CITY OF ALBUQUERQUE CAPITAL IMPLEMENTATION PROGRAM			
PROJECT TITLE:	JOHN MARSHAL KITCHEN REPLACEMENT FACILITY 2540 KARSTEN COURT SE ALBUQUERQUE, NM		
DRAWING TITLE:	GRADING AND DRAINAGE PLAN HYDROLOGY SECTION		
Design Review Committee	City Engineer Approval	Update	MO/DAY/YR
		SD: 11/03/2009	
		EPC: 01/07/2010	
		DO: 01/19/2010	
		SOCOD: 03/30/2010	
		1000CD: 04/15/2010	
City Project No.	Zone Map No.	DRAWING:	Sheet Of
7686.02	M-14-Z	C 2.0	9 98

TEMPORARY DRAINAGE CERTIFICATION

TITLE:
JOHN MARSHAL KITCHEN REPLACEMENT FACILITY
2540 KARSTEN COURT SE
ALBUQUERQUE, NM

DRAWING TITLE:			
GRADING AND DRAINAGE PLAN			
Design Review Committee	City Engineer Approval	MO./DAY/YR.	MO./DAY/YR.
		SD: 11/03/2009	
		EPC: 01/07/2010	
		DD: 01/19/2010	
		50%CD: 03/30/2010	
		100%CD: 04/15/2010	
City Project No.	Zone Map No.	DRAWING:	Sheet of
7686.02	M-14-Z	C 2.0	9 98

1 CONCEPTUAL GRADING AND DRAINAGE PLAN

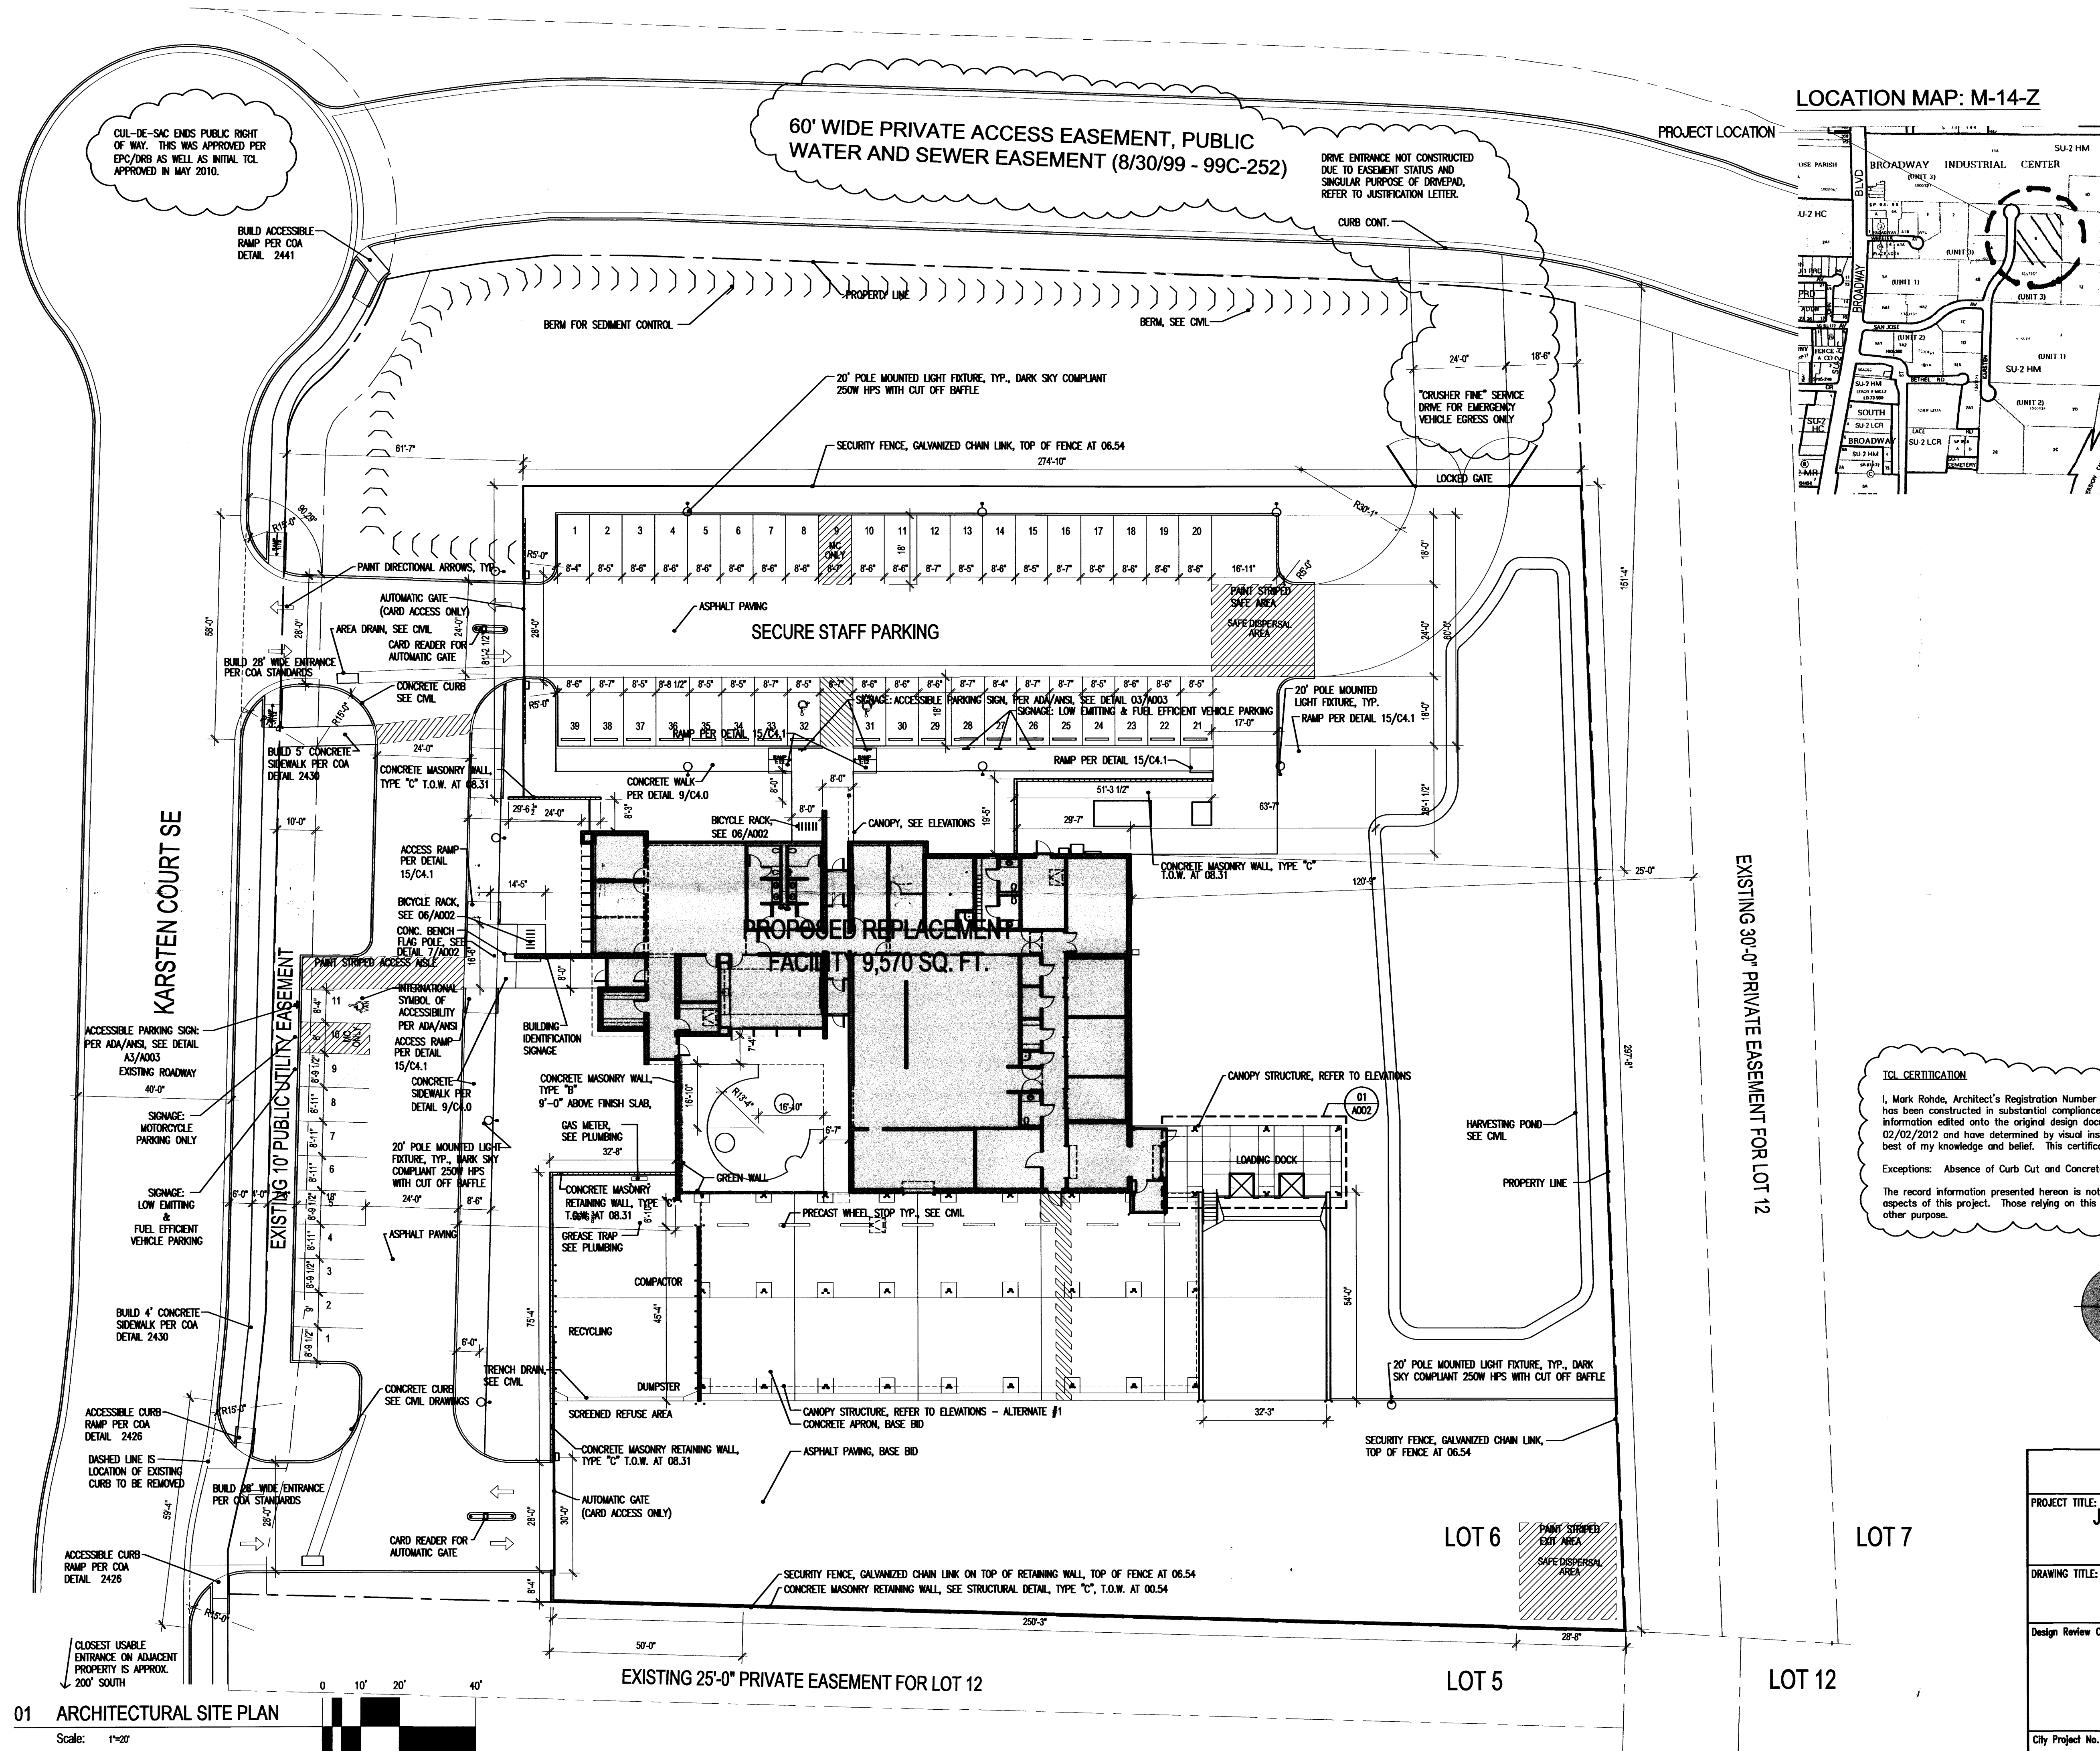
CORRECTIONS NEEDED:

1. MORE SURVEY NEEDED TO VERIFY ADA PARKING
2. POND NOT CONTAINED. NEED BERM.
3. INVERT SLOPES WRONG DIRECTION.

Exceptions: Exceptions as noted on the plan. Corrections needed are also noted on the plan.

Storm Drains
Lead where?
